PLANNING RESPONSES
SUNLIGHT HOUSE
APRIL 2023

EXTERNAL ALTERATIONS

INTERNAL ALTERATIONS

14. LEVEL 7 AND 9

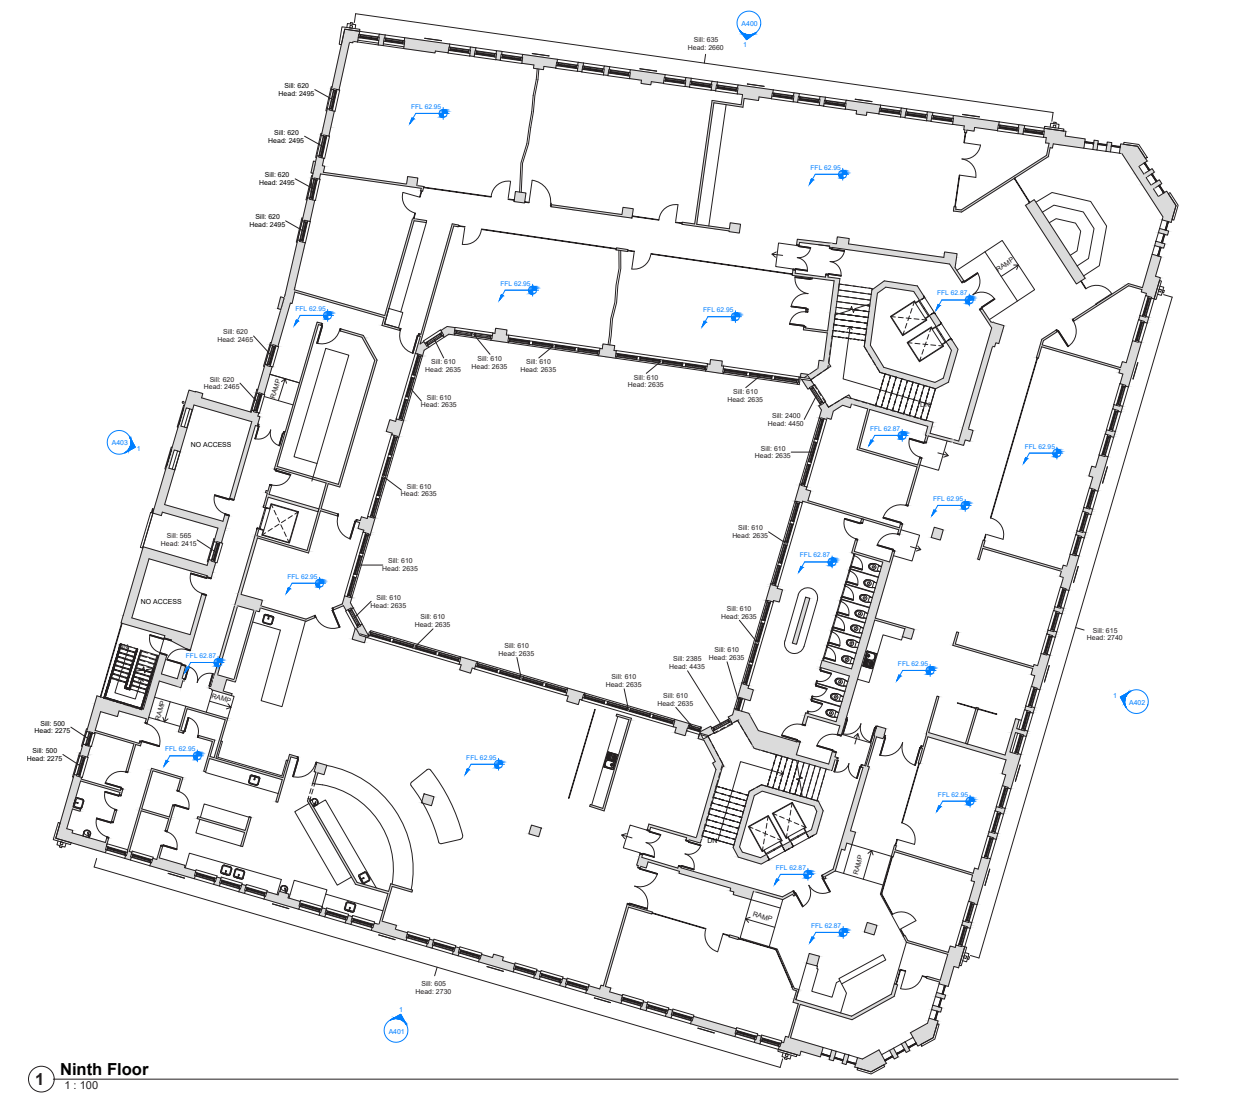
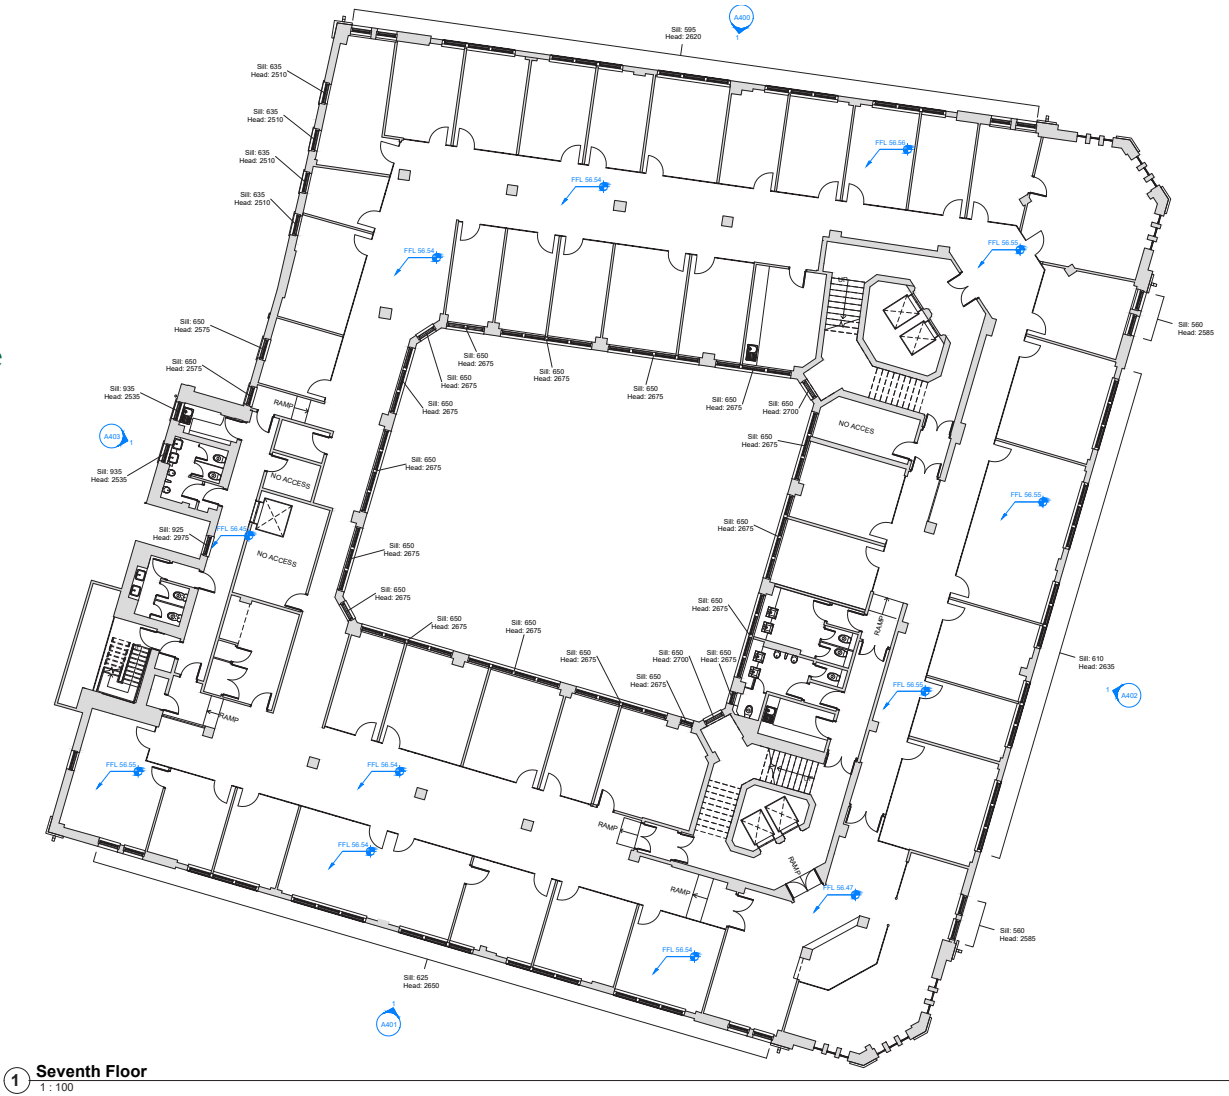
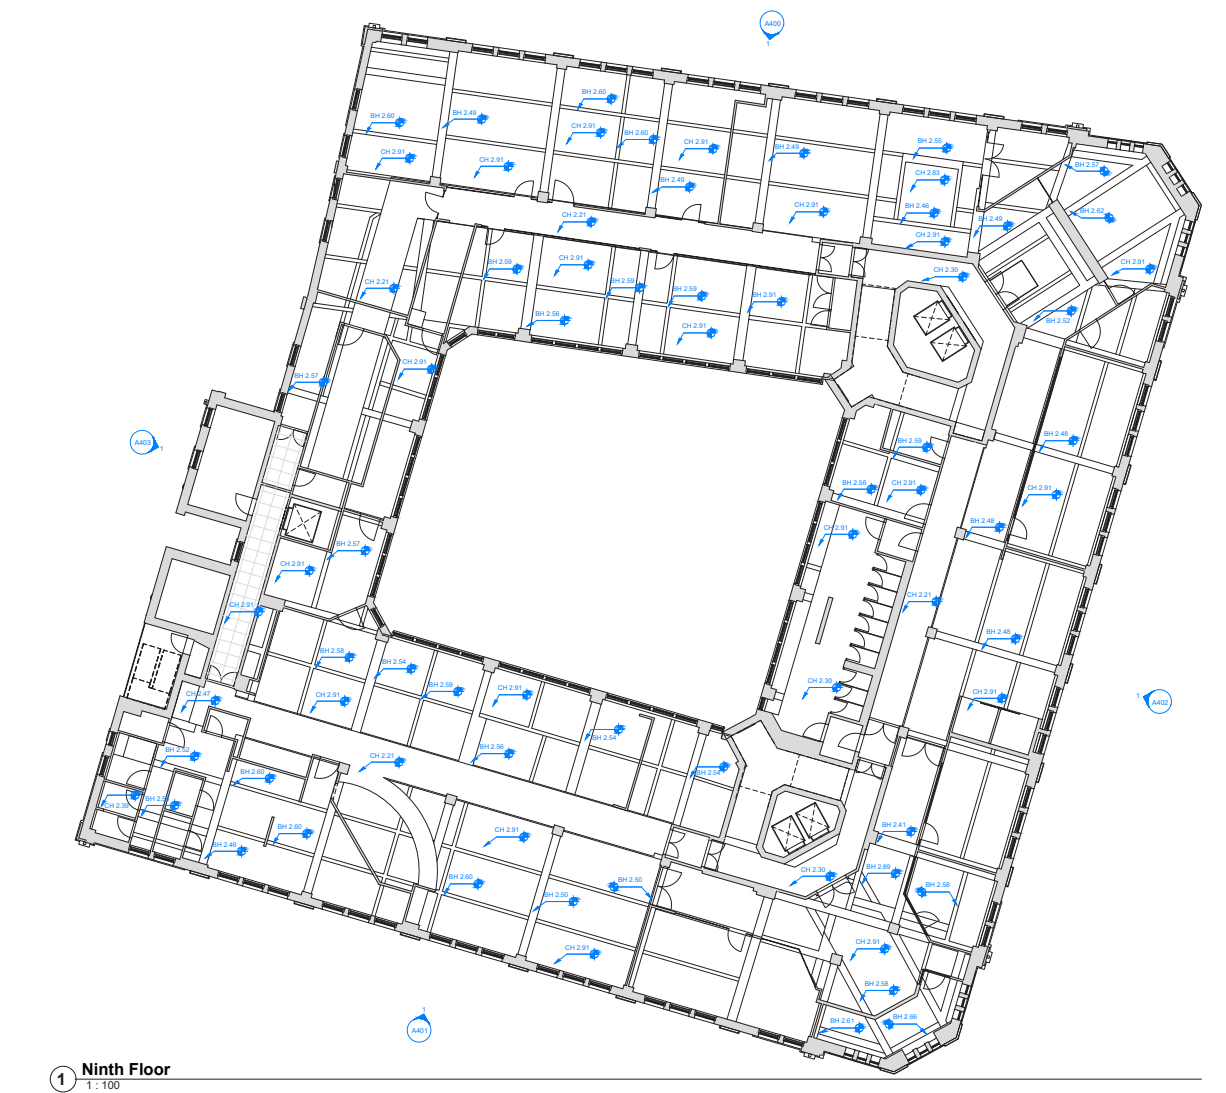
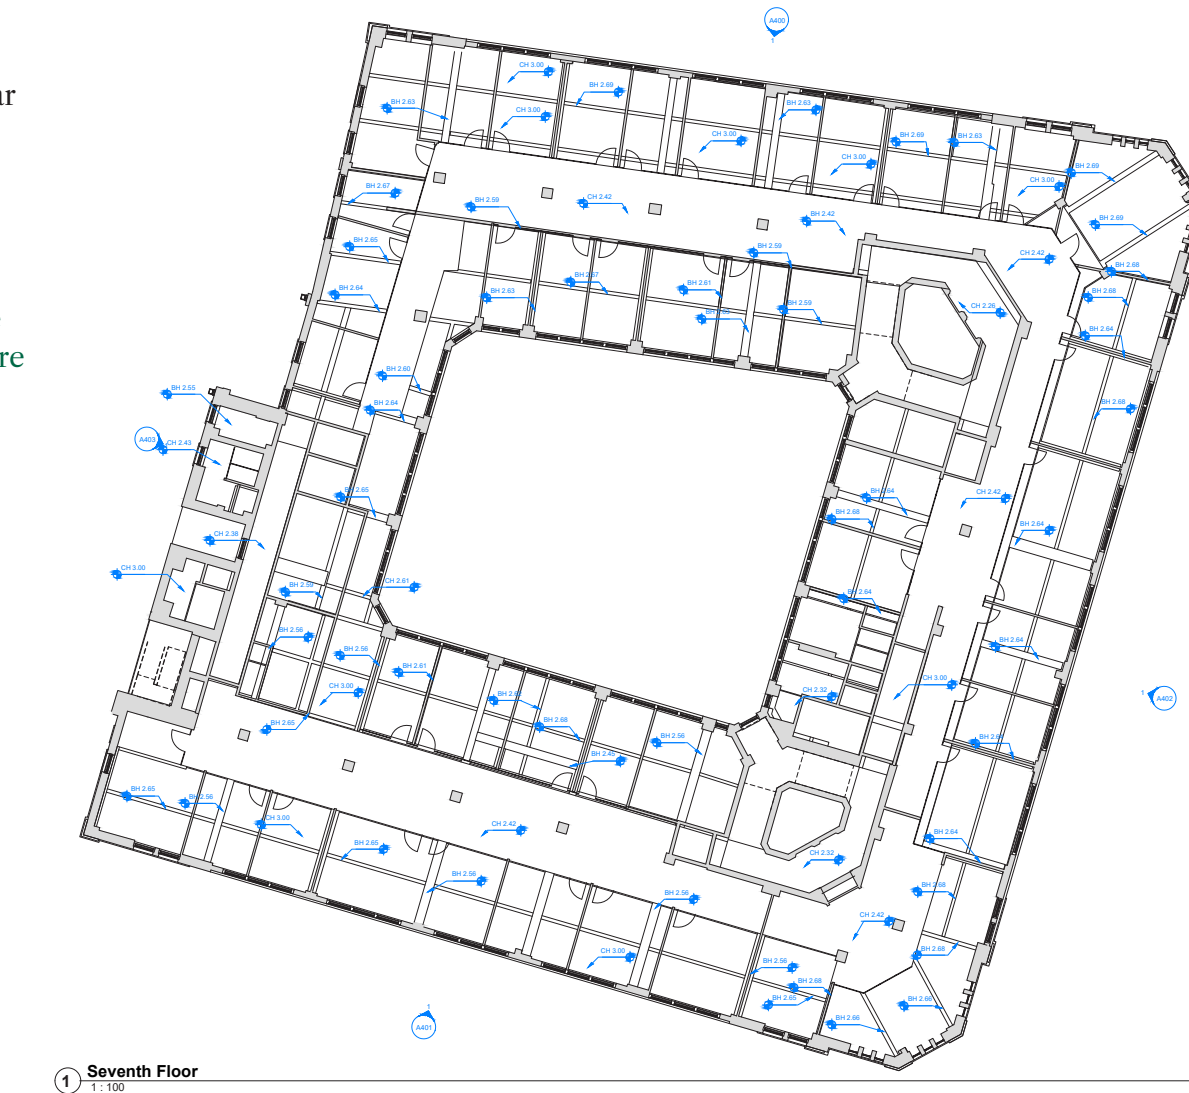
The existing and proposed level 7 and 9 do not appear to be a correct representation of the existing and/or proposed floorplans.

Would be good to clarify this comment further, as we still don't quite understand the query. Level 7 and 9 are currently very subdivided based on tenant fitout.

Drawing Title
Proposed Reflected Ceiling Plan - Level 01

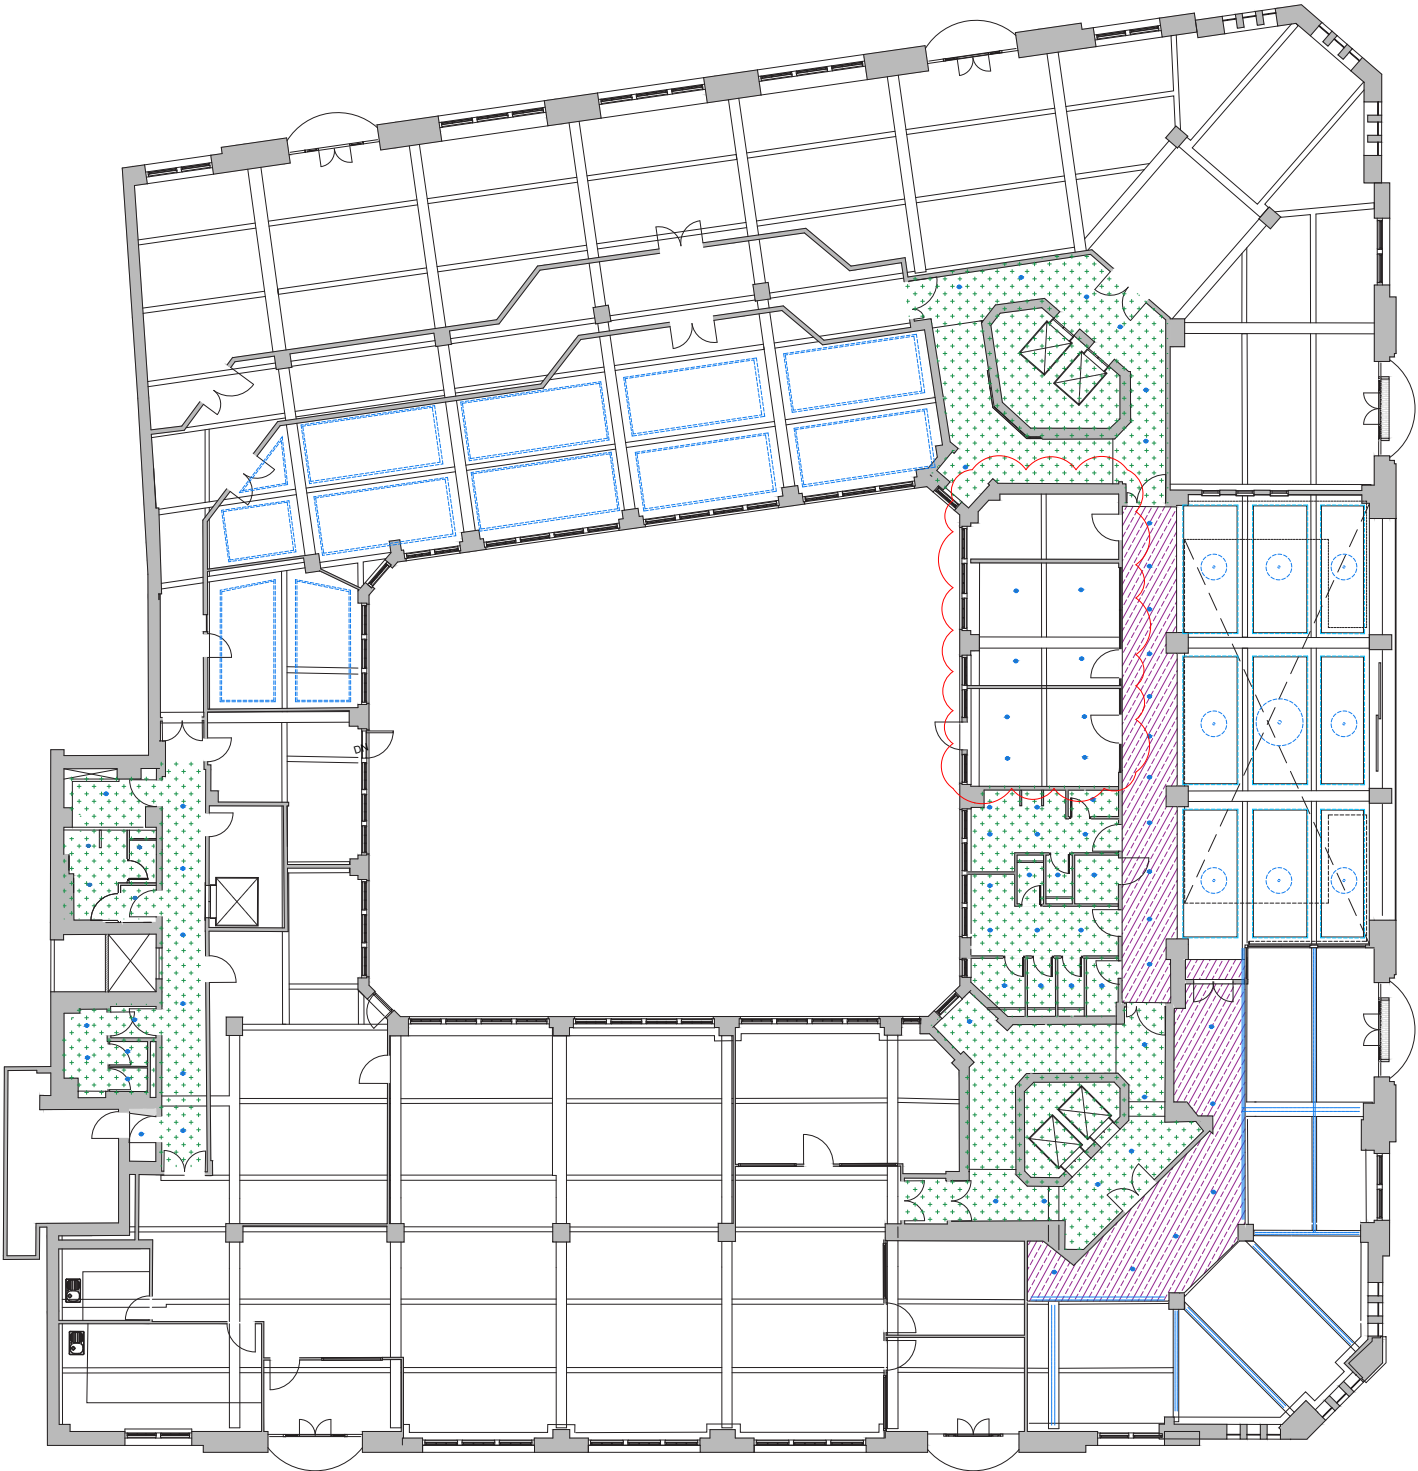
We need to review the most recent ceiling plans.
The previous information did not show the areas of the existing suspended ceilings across the interior of Sunlight House and therefore it has not been possible to review whether the proposed changes would be better or worse than the current situation.

We believe this has now been responded to - all comments noted on the additional information required and areas that were mislabeled.

All have been agreed with aside from necessity of maintaining dropped ceiling in WC core.

Drawing Title
Proposed Reflected Ceiling Plan - Level 10

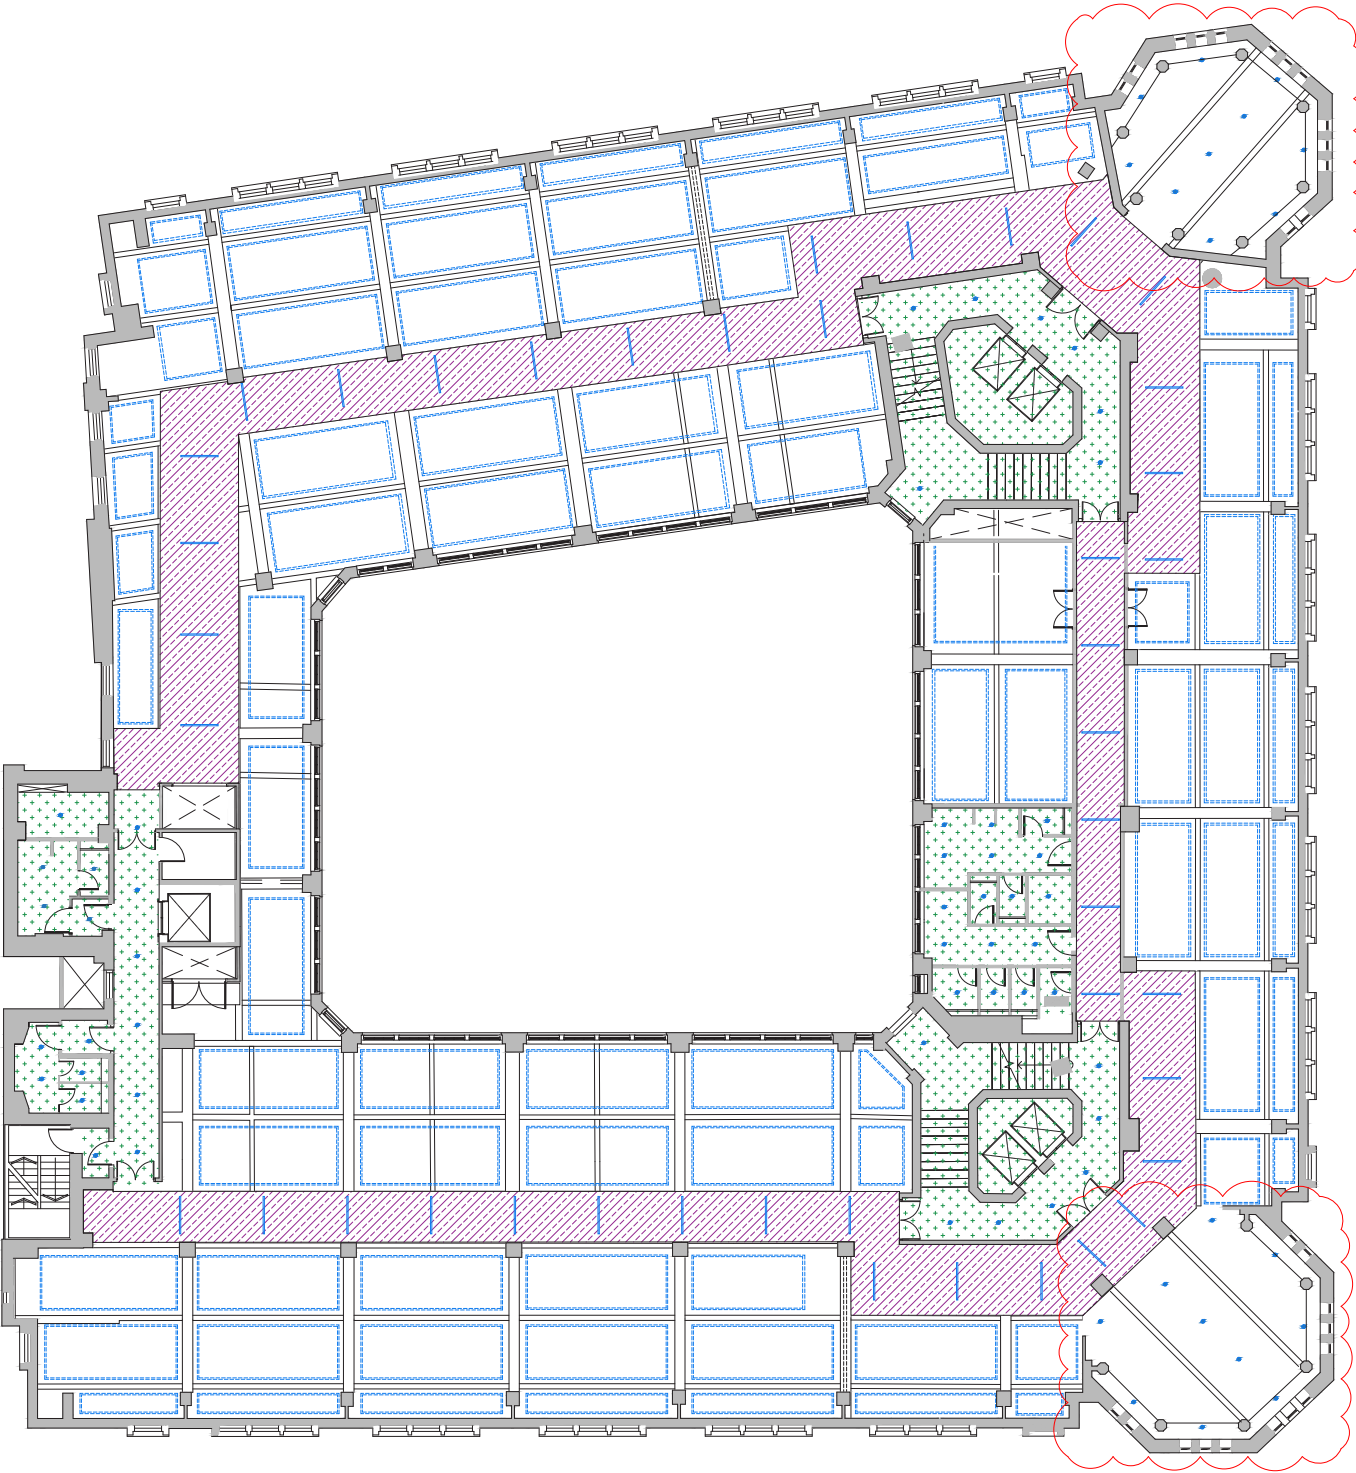
We need to review the most recent ceiling plans. The previous information did not show the areas of the existing suspended ceilings across the interior of Sunlight House and therefore it has not been possible to review whether the proposed changes would be better or worse than the current situation.

We believe this has now been responded to - all comments noted on the additional information required and areas that were mislabeled.

All have been agreed with aside from necessity of maintaining dropped ceiling in WC core.
